Safety Evaluation Report

related to the operation of
River Bend Station

Docket No. 50-458

Supplement No. 4 to the Safety Evaluation Report on the application filed by Gulf States Utilities Company as applicant and for itself and Cajun Electric Power Cooperative, as owners, for a license to operate River Bend Station has been prepared by the Office of Nuclear Reactor Regulation of the U.S. Nuclear Regulatory Commission. The facility is located in West Feliciana Parish, near St. Francisville, Louisiana. This supplement reports the status of certain items that had not been resolved at the time the Safety Evaluation Report and its first three supplements were published.

Figure 6:5 Wetwell temperature: Stuck-open relief valve, base case
 Source: Licensee's letter of June 7, 1983, Figure 3

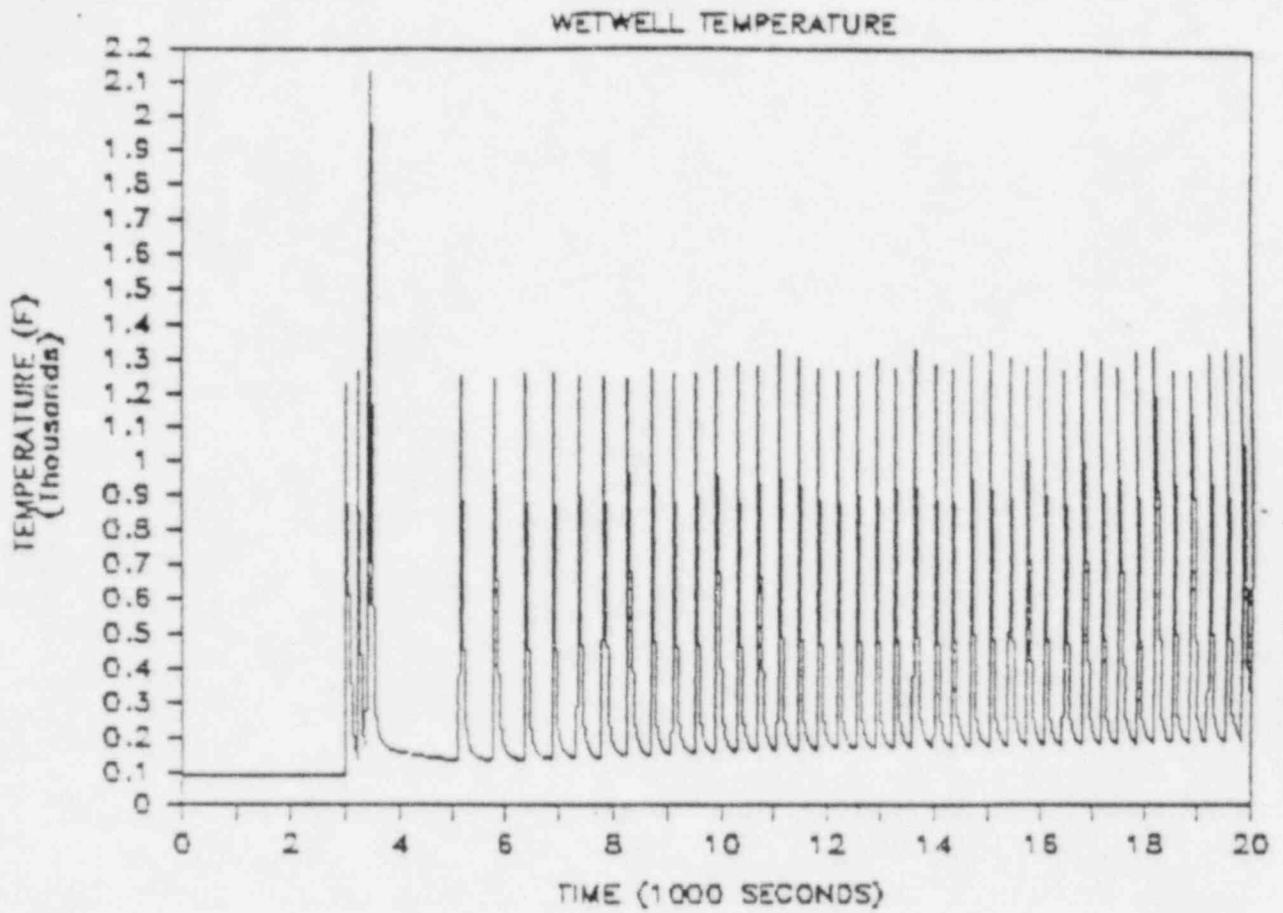
assumed to occur at 8% hydrogen concentration with a flame speed of 6 feet per second. The River Bend SORV base case produces a transient in which the hydrogen is ignited in a series of burns in the wetwell volume. The CLASIX-3 Code predicts a sequence of 42 wetwell burns (approximately 40 pounds of hydrogen per burn). Figures 6.5 and 6.6 show the wetwell temperature and pressure profiles. Referring to the wetwell temperature transient, the third burn resulted in the highest wetwell temperature (2135°F) for the entire transient; this burn is a consequence of the peak hydrogen release. Otherwise, the remaining wetwell burns produce a peak wetwell temperature of about 1300°F.

Previously submitted preliminary analyses performed by Mark III owners, i.e., Grand Gulf and Perry, used the CLASIX-3 wetwell thermal profiles (SORV) case as the atmospheric boundary condition for the equipment survivability analysis. This wetwell temperature profile was also applied to essential equipment outside the wetwell region, because it represents the bounding profile and those plants were able to accommodate this most severe environment. Containment sprays were assumed to be available for the Grand Gulf and Perry preliminary analysis. Water sprays, if available, are an effective way to reduce atmospheric temperatures. However, the licensee does not use containment sprays in the River Bend plant. As a result, the licensee found it necessary to refine its CLASIX-3 analysis and has provided a revised SORV case, which is discussed below.

Figure 6.6 Wetwell pressure: Stuck-open relief valve, base case
Source: Licensee's letter of June 7, 1985, Figure 7

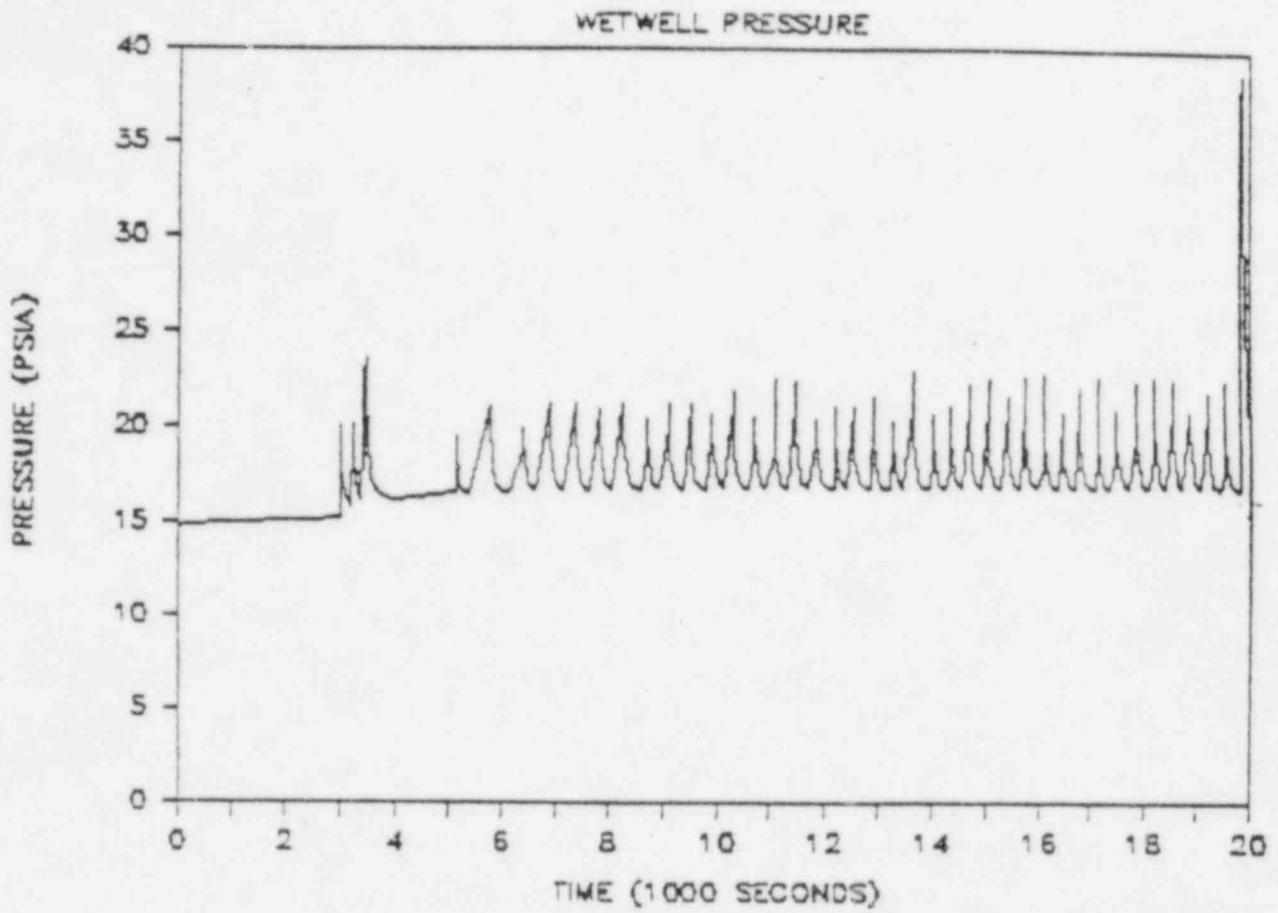
At the end of the hydrogen release period, the hydrogen concentration in the containment volume does not reach the ignition setpoint of 8%; the average concentration of hydrogen in the containment volume is about 6.5%. The licensee induced the only containment burn at the lower concentration and this resulted in the most severe pressure excursion to approximately 24 psig.

Figure 6.7 Wetwell temperature: Stuck-open relief valve, revised base case
 Source: Licensee's letter of August 19, 1985, Figure 3

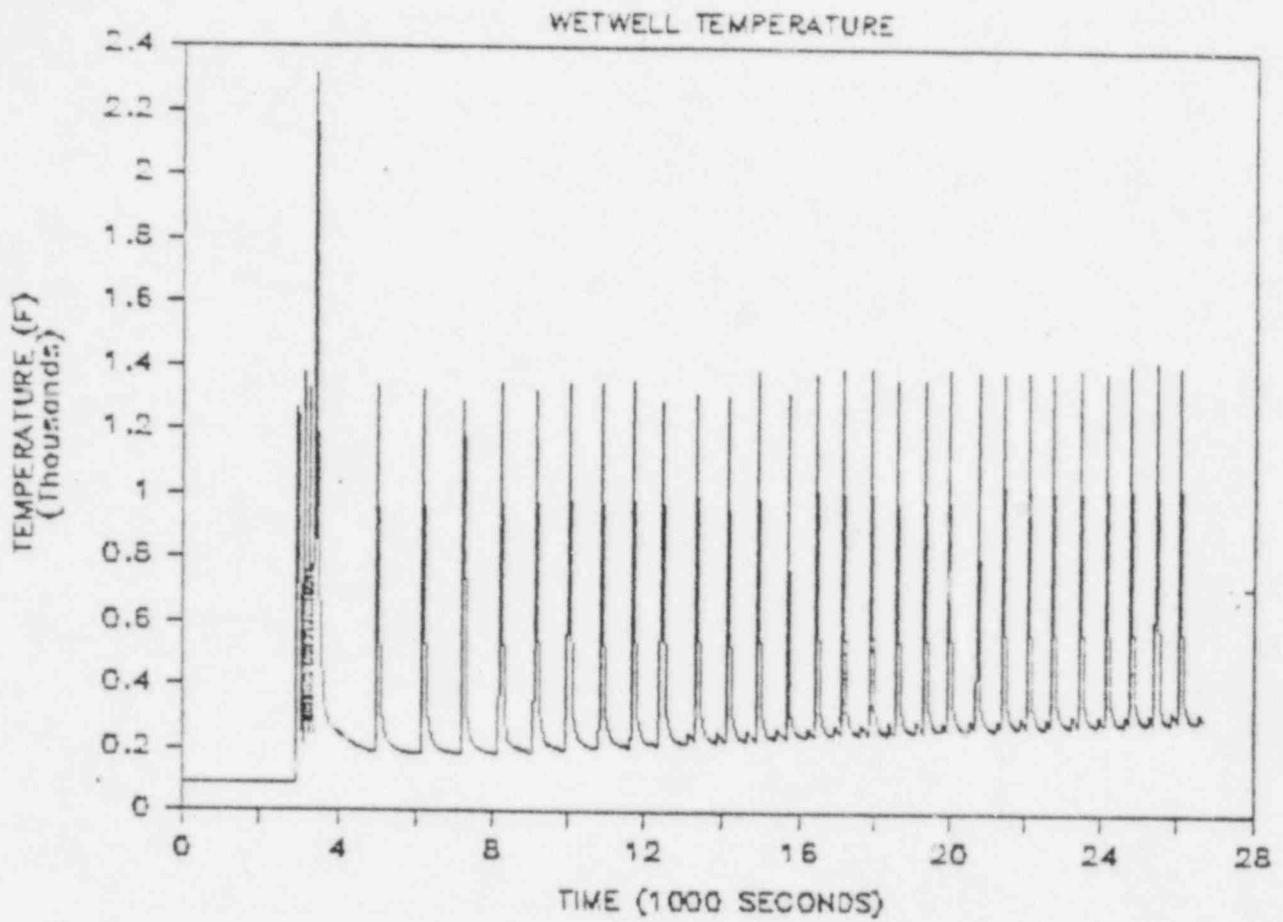
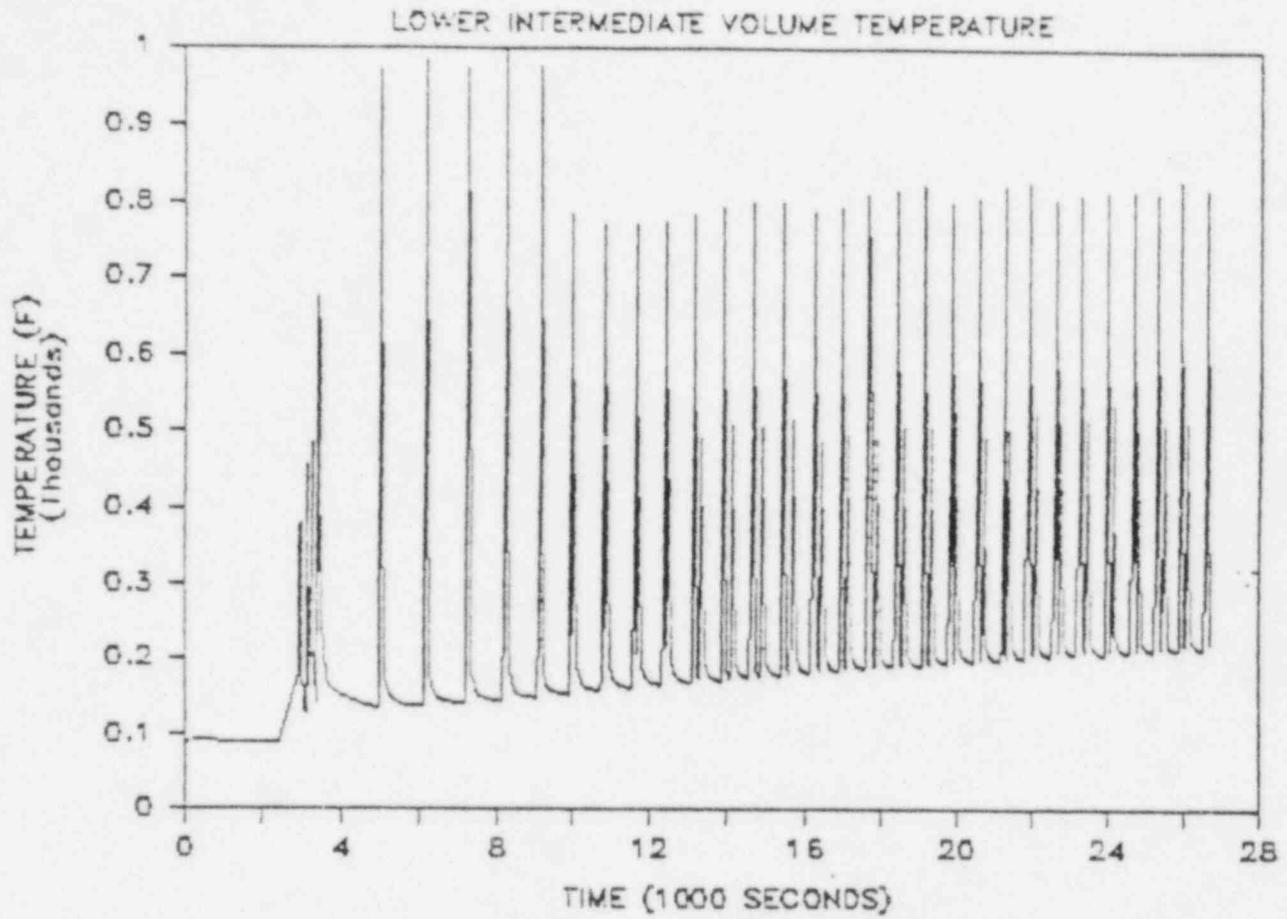
The revised River Bend SORV base case produces a transient in which the hydrogen is ignited in a series of burns confined to the wetwell volume (39 burns) and the lower intermediate volume (29 burns). Figures 6.7 and 6.8 show the respective volume temperature profiles.

In reviewing the overall CLASIX-3 Code containment modeling used in the preliminary analysis, certain assumptions need to be justified. The licensee will address these concerns in the final analysis and will submit the justifications to the staff for review. If the final containment environmental profiles are found to be more severe than the present analysis, the licensee will have to, and has committed to, confirm equipment survivability with the modified profiles or initiate appropriate equipment modifications as necessary. The staff concludes that the licensee's preliminary analysis of the containment constitutes a reasonable methodology for demonstrating the performance of the HIS on the basis of the above findings.
